STAFF REPORT

PLANNING & ZONING COMMISSION

1. FINAL DEVELOPMENT PLAN REVIEW

Request: To approve a Final Development Plan for a proposed 308 residential unit active adult community, and 5 acres of planned commercial development on roughly 39 acres.

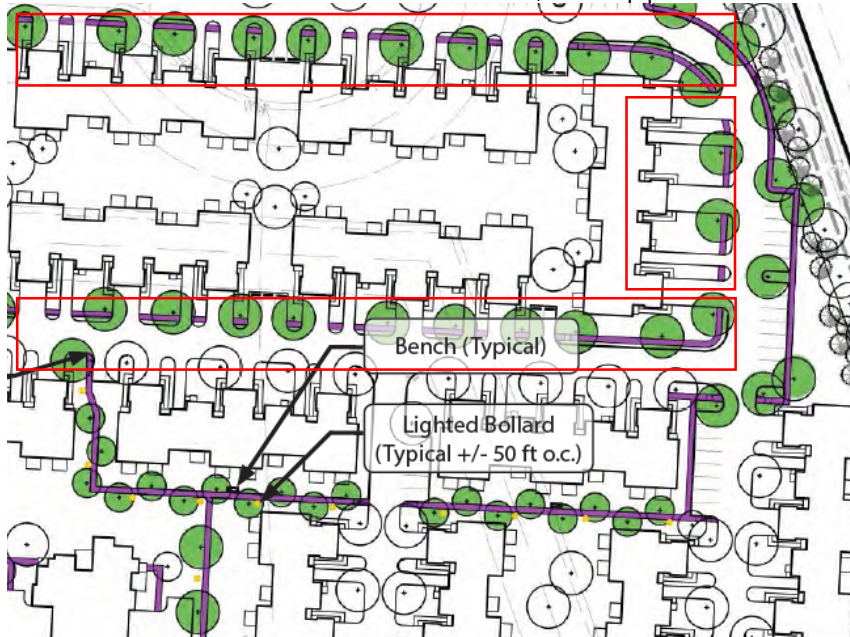
- The final development plan has not changed substantially since the last submission.
- There were some refinements to area dimensions (e.g. Subarea B went from 10.40+/- in the preliminary plan to 10.29 in this version). As a result, density calculations changed slightly (e.g. subarea A had a net density of 22.10, it is now 22.09 du/ac). All minor changes are still in line with zoning code requirements.
- Impervious surface coverage reduce from 43% to 48.1%.
- A new landscape buffer has been provided, as per staff's recommendations, along Bunker Lane at the northwest corner of the site.
- Exhibits I A4.01, A4.02, and P-1 new.
- There is now a walkway between the community gardens and the dog park.

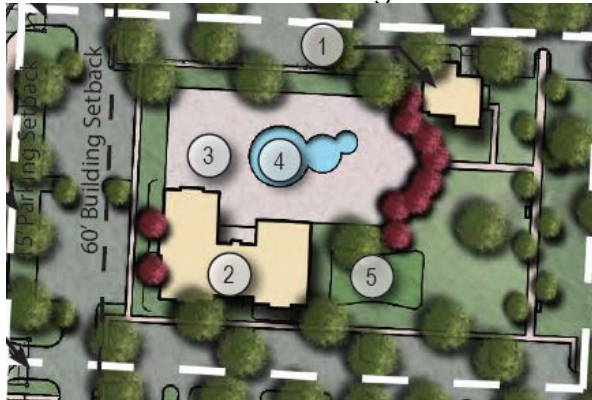
- As a result of staff's recommendation, the applicant added more pathways to the plan.

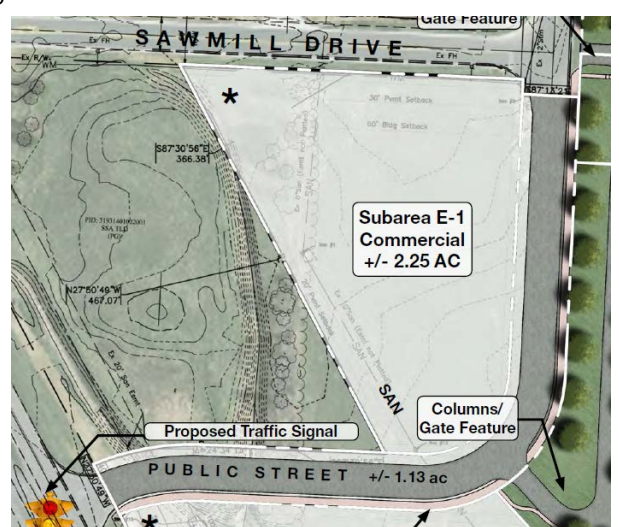
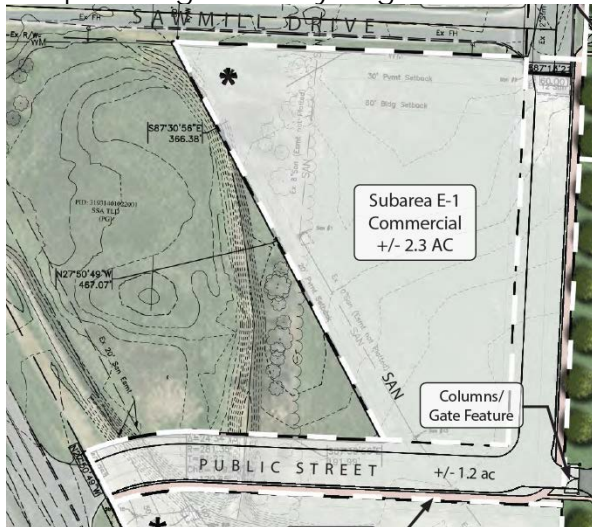
- The most substantial change is the reorientation of the club house.

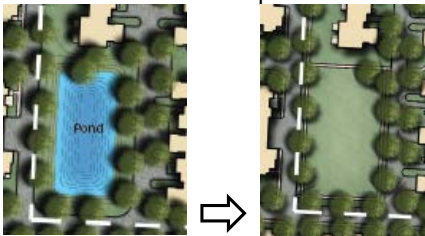
- Changes since June 10 preliminary submittal:
 - o Removed courtyards from A buildings.

Landscaping:

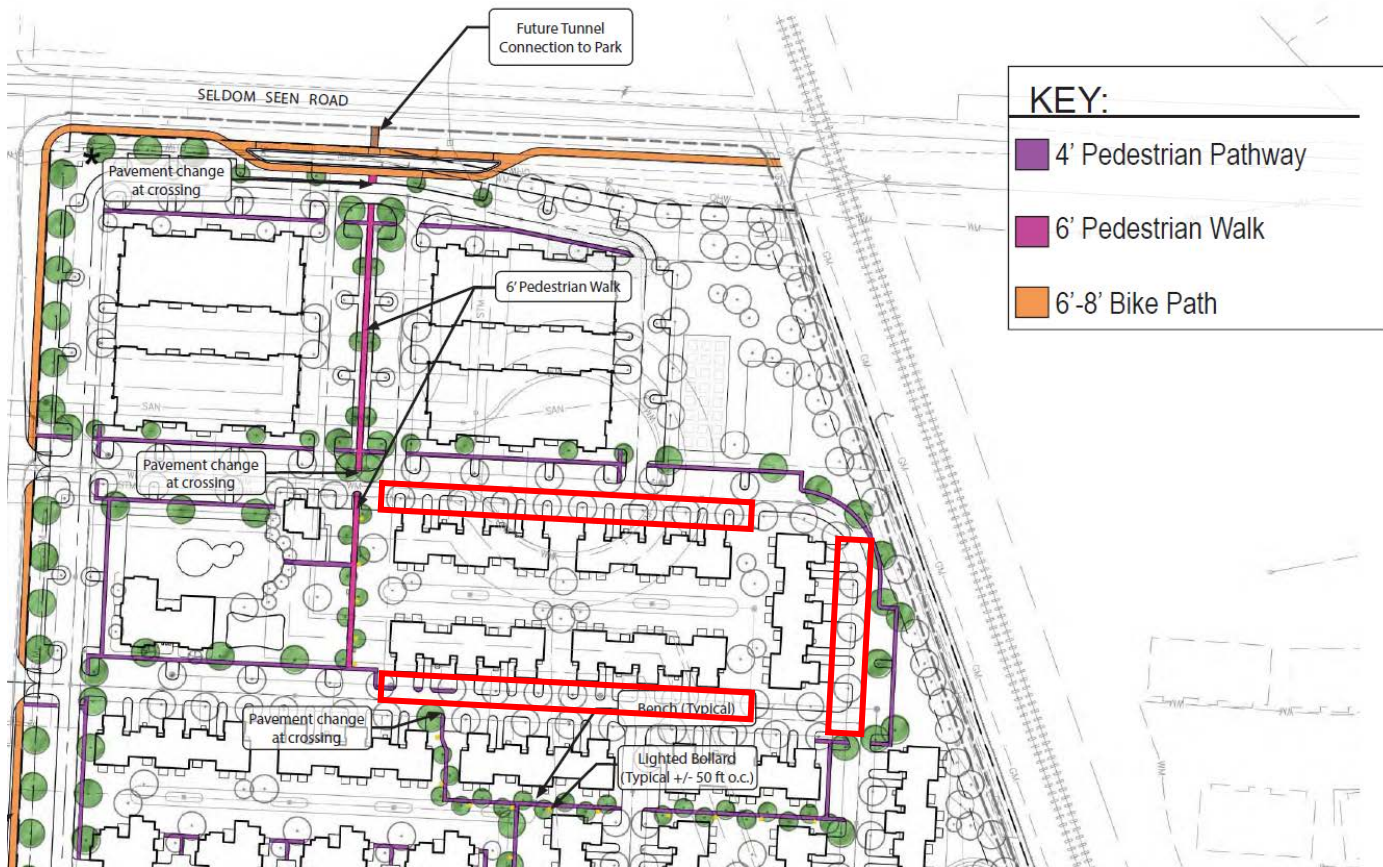
Site wide landscape plans only show trees, mostly deciduous. Staff believes additional plantings, in the form of shrubs, grasses and mounding, along the northwest corner are needed to screen the row of garage bays. Those bays are visible to travelers headed east along seldom seen (shown in developer rendering). Screening will provide more aesthetic sightlines for drivers and increased privacy for residents.

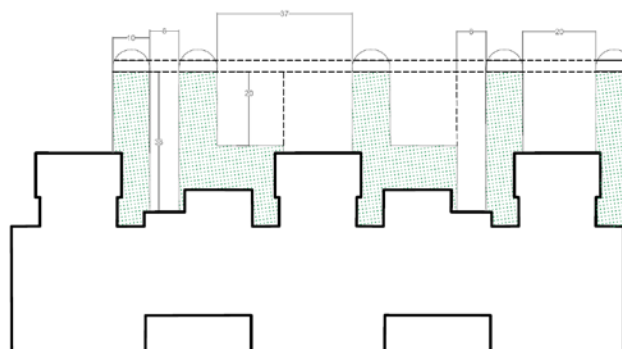
While the developer has added more pathways in this iteration, large sections of the development are not serviced with paths along lot frontage. Specifically, the C type buildings are without front sidewalks. This is important to note as C type buildings account for the majority of units and land area. C type builds are also along one (of the three) of the major access roads.

Staff just received the Traffic Study on Friday. We will update this report later. Staff does have an issue with the interior sidewalk plan related to the depth of parking driveways for the townhomes. The depth of parking areas are not deep enough. See the images on the next page. We need the applicant to pinch the rear of the townhome buildings a few feet closer together to create better parking situation where the parking does not interfere with sidewalks"

Ultimately, not providing sidewalks results in lower mobility, safety of walkers, and property values.

Ideal

Architecture:

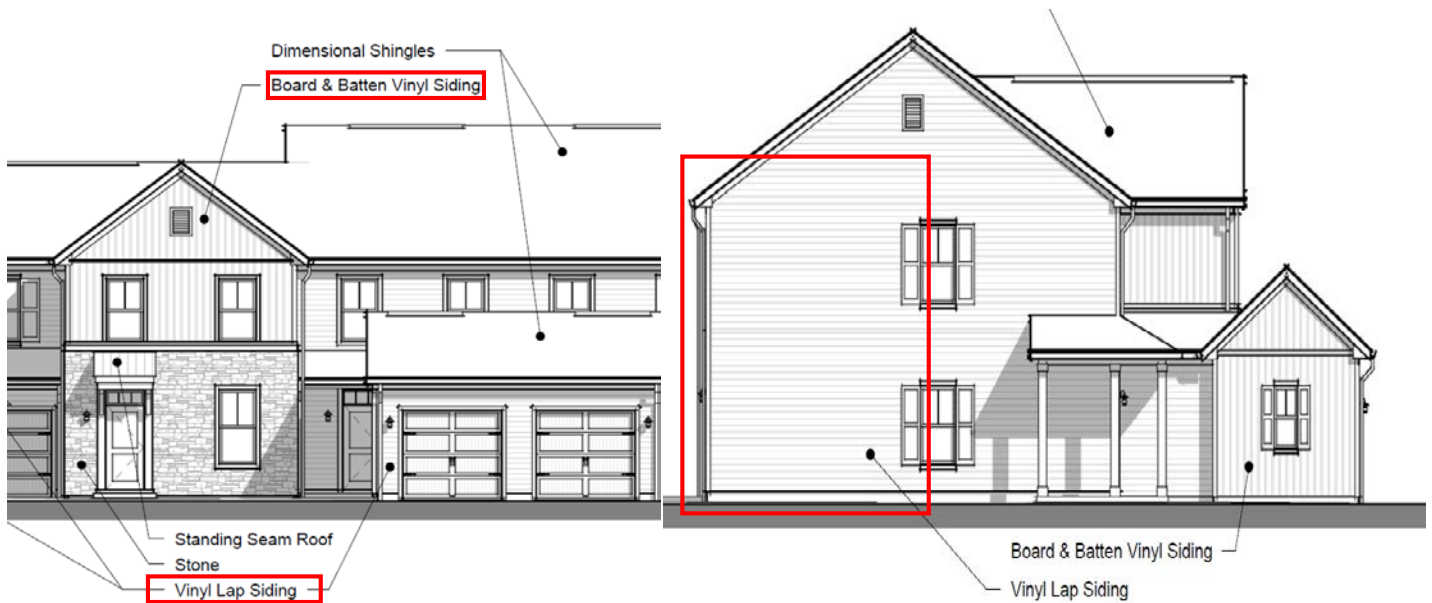
Staff defers to the architectural Advisor for comments. However, staff would like to make mention that the vinyl siding proposed is not appropriate for high quality buildings that the applicants are proposing (see image below). Staff would recommend cementitious siding be used instead. Furthermore, staff would like to see some of the blank walls be reduced (see image below)

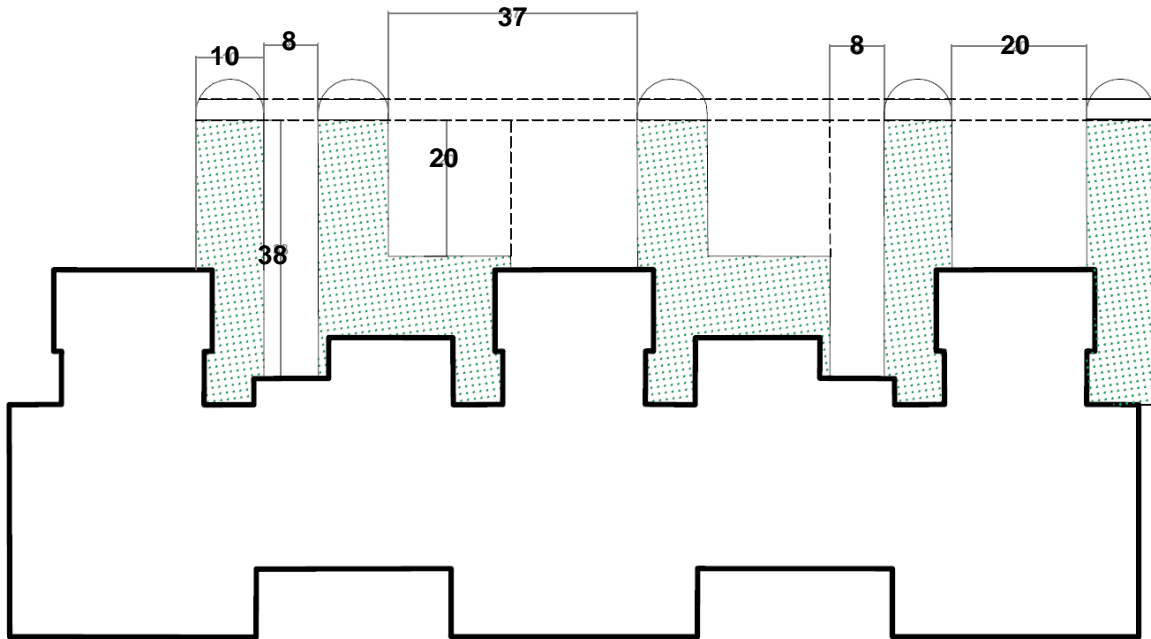
Staff just received the Traffic Study on Friday. We will update this report later. Staff does have an issue with the interior sidewalk plan related to the depth of parking driveways for the townhomes. The depth of parking areas are not deep enough. See the images on the next page. We need the applicant to pinch the rear of the townhome buildings a few feet closer together to create better parking situation where the parking does not interfere with sidewalks.

Ideal
